H. B. ROBINSON UNIT NO. 2  
 LICENSE DPR-23

ADDITIONAL INFORMATION CONCERNING LOSS-OF-COOLANT ANALYSES

H. B. ROBINSON UNIT NO. 2  
LICENSE DPR-23  
ADDITIONAL INFORMATION CONCERNING LOSS-OF-COOLANT ANALYSES  
September 28, 1973

FIGURE 1

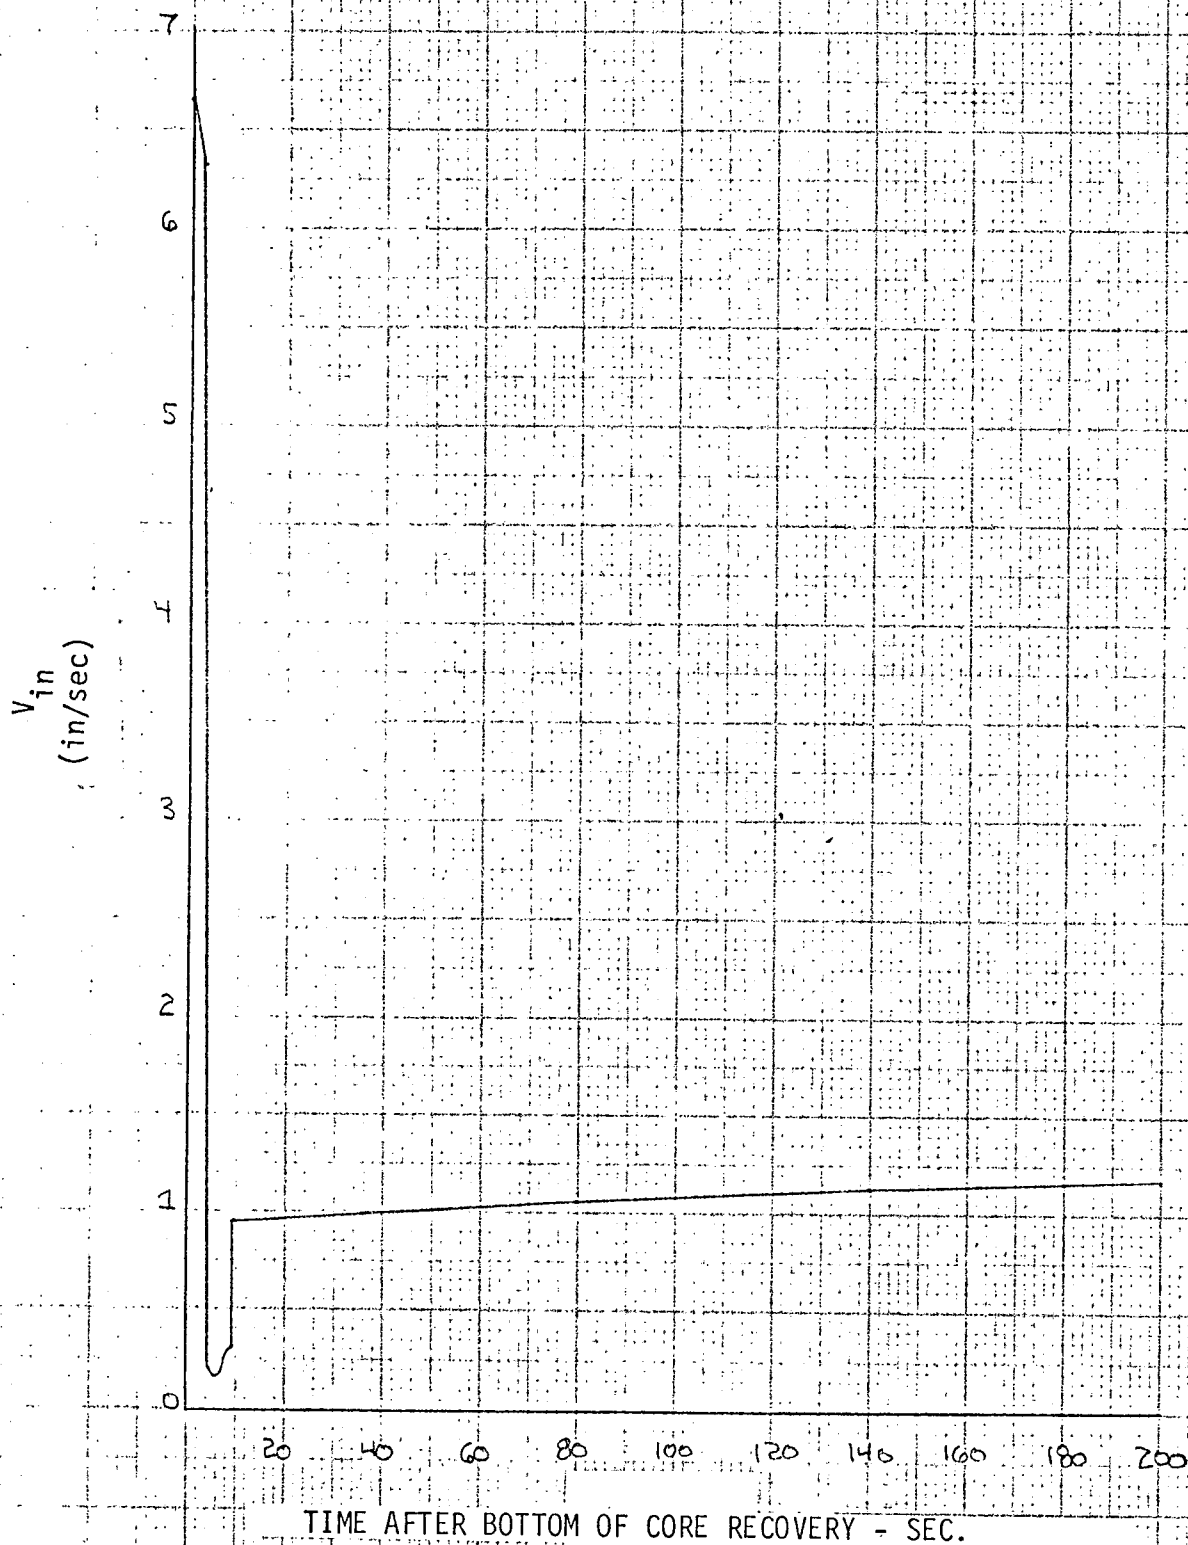
Present the core reflooding rate as a function of time.

See Figure 1.

FIGURE 2

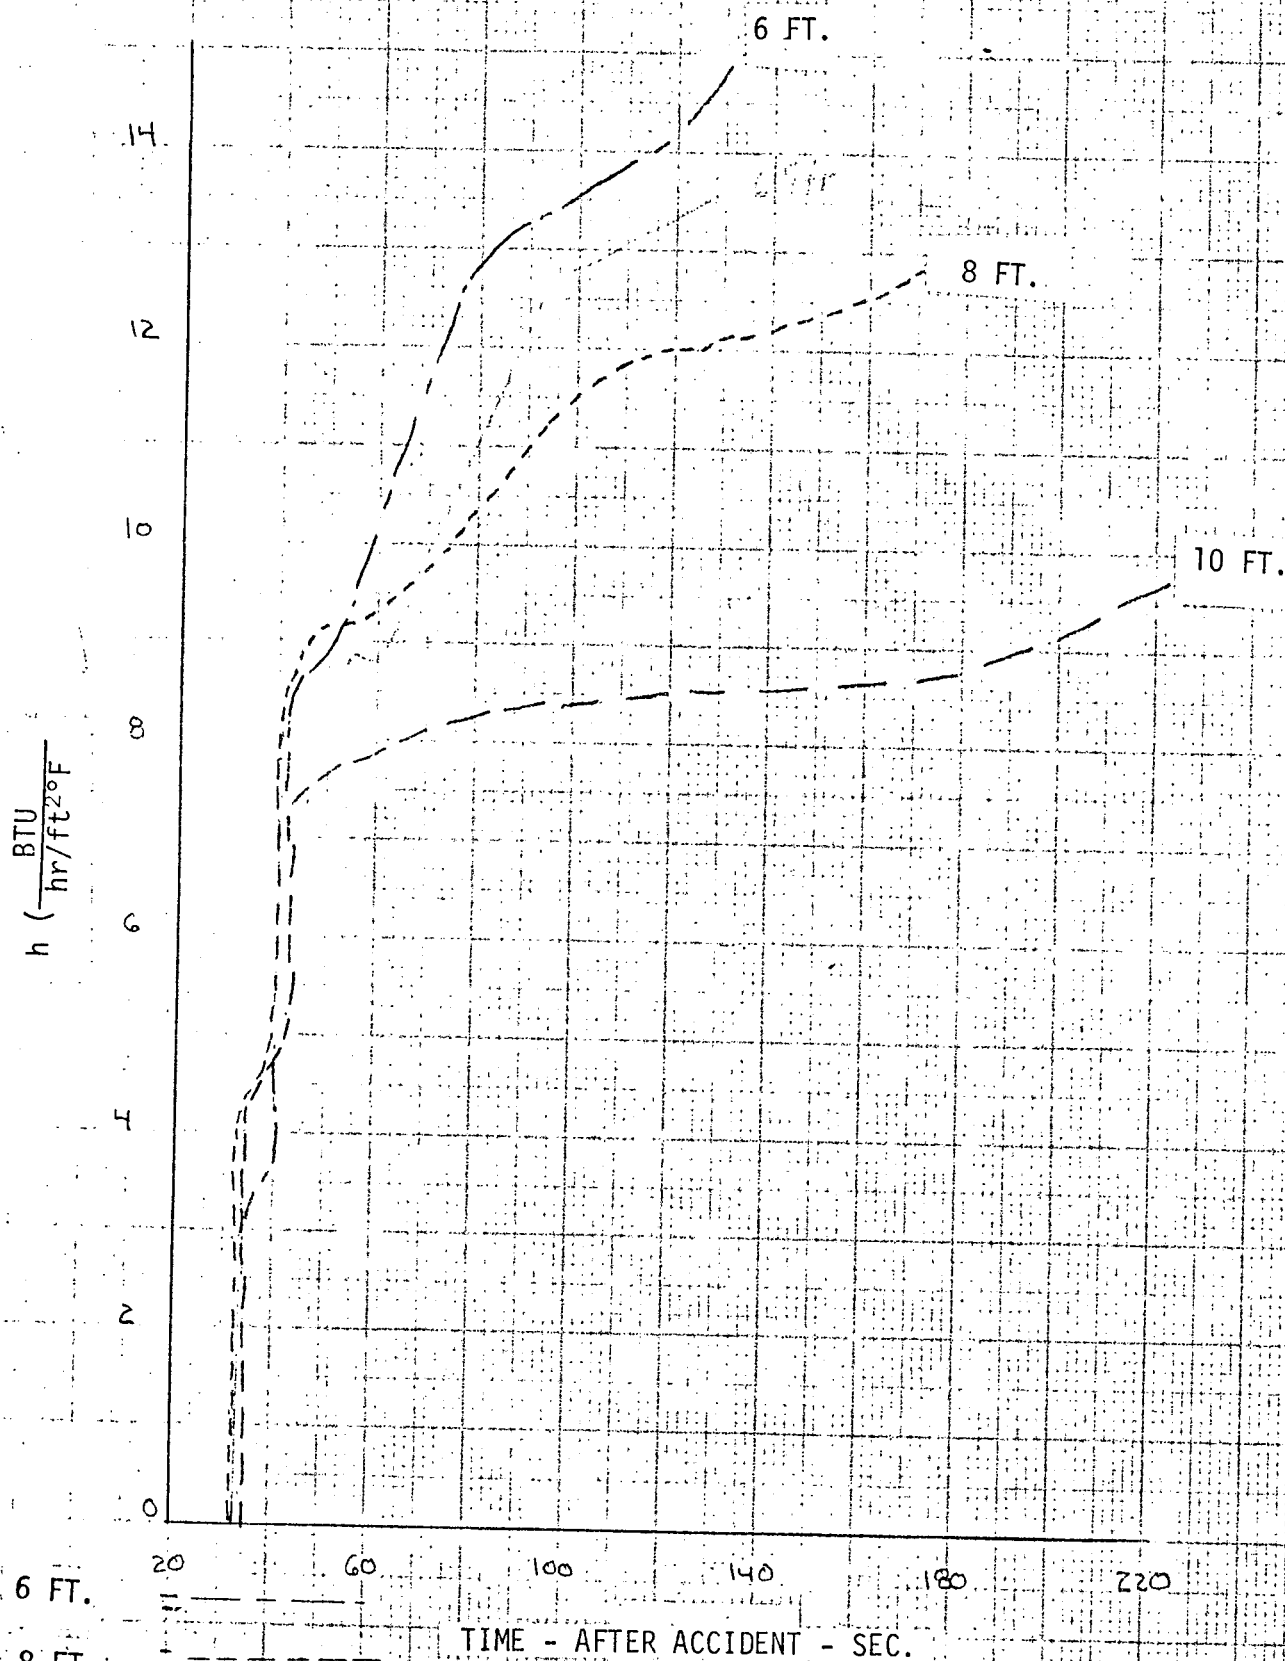
Discuss the values of the thermal heat transfer coefficient during reflooding of the core.

Plots of the calculated FLECHT heat transfer coefficient used in the analysis for different elevations are shown in Figure 2. As the figure shows, the heat transfer decreases with increasing elevations. This is borne out by the data in WCAP-7931. Again, the low values at early times are believed due to the larger heat release to the fluid since the power peak is below the elevation being examined.
